STAFF RECOMMENDATION

1514 Cedar Lane

May 16, 2018

Application: New construction- addition; Partial demolition

Figure 2: Windows to be removed

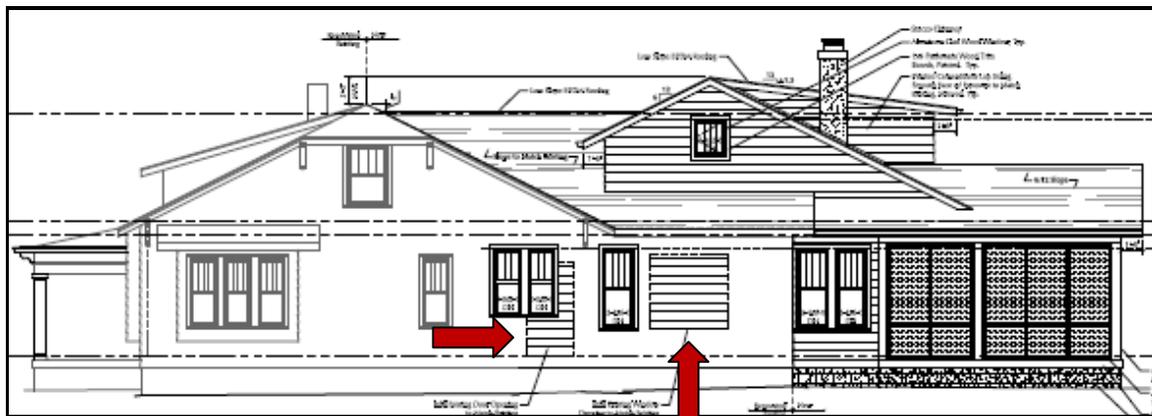
The request includes the removal of two existing window openings on the right side façade, replacement of porch posts, and extending the eave on the front porch to protect the wood exposed rafter tails. The window openings to be removed are located on the side façade near the rear of the house (Figure 2). According to the 1951 Sanborn map, a covered porch that has since been enclosed was located at the same location as one of the windows to be removed, so that window opening is not original (Figure 3). Enclosure of both is appropriate because of their location towards the rear of the house on a secondary façade.

Figure 4: Eave to be extended to protect wood exposed rafter

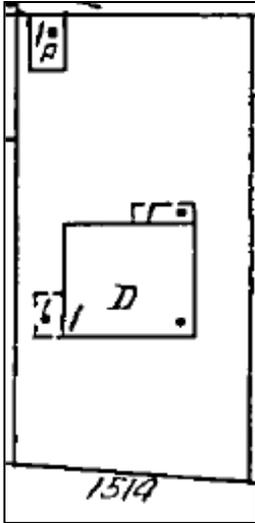
The plan also proposes extending the eaves on the covered stoop to cover wood exposed rafter tails (Figure 4). Currently the rafter tails are exposed and the wood has rotted due to water damage. While changes to the front of an historic house are inappropriate and this appears to be the original design, staff finds that the proposed alteration could be appropriate since it is proposed to address maintenance issues, could be reversed without damaging the building and does not greatly impact the character of the historic house.
